<b>AMENDMENT OF SOLICITATION/MODIFICATION OF CONTRACT</b>			1. Contract Number	Page of Pages 1   1
2. Amendment/Modification Number DCAM-2008-B-0089-004	3. Effective Date 23-Jul-08	4. Requisition/Purchase Request No.		5. Solicitation Caption Classroom Renov, Rm A04 Bldg 46W

## Classroom Renovations, Room A04, Building 46W

### DCAM-2008-B-0089 Additional Questions and Answers

UDC - VAN NESS CAMPUS  
BUILDING 46W - RECITAL HALL  
Temporary Sconce Locations

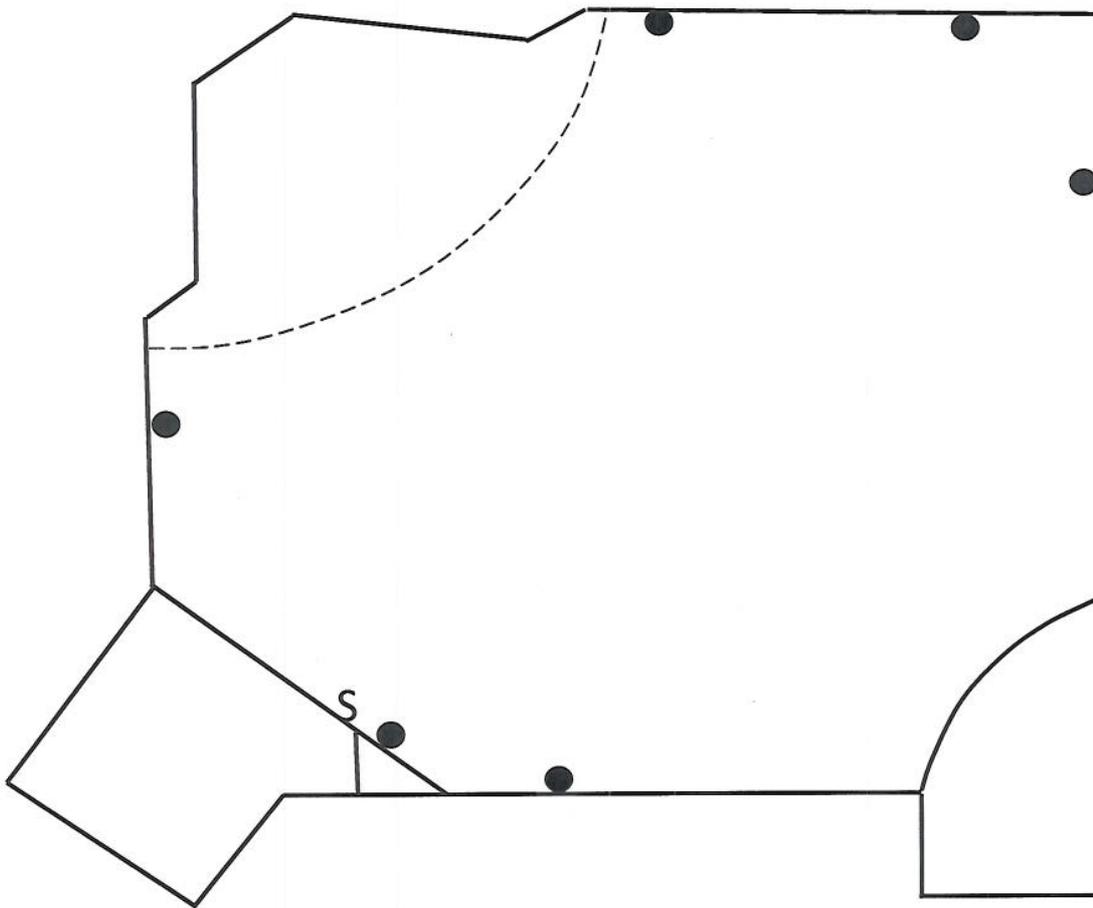
- A:** Concur. No action required.
- (23). **Q:** Ref: Scope of Work conflicts with Lighting Fixture Schedule, Drawing 46W-E-2:  
Scope of Work dated June 19, 2008, Note 6 call to provide and Install six (6) Type D Sconces (wall mounted light fixtures). Drawing 46W-E-2 Lighting Fixture Schedule calls for Type D LED wall washer.

- A:** Please determine Type of fixture for Sconces;

- B. Please indicate temporary location of 6 Sconces. (Final location will be determined in the field);
- C. Please provide exact location of switches on each wall for the 6 Sconces.

**A:** The specifications for the Type D sconces are as follows:

- a. Manufacturer/Cat# - VISA CB 6286**
- b. Lamps – 50W MR 16**
- c. Volts – 120**
- d. Brushed Brass finish for the face plate**

**See attached sketch for temporary location of sconces and light switches.**

● - Temporary Location of Sconces ( Final location to be determined in the field)

S - Switch for Sconces ( To be added to existing switchbox)
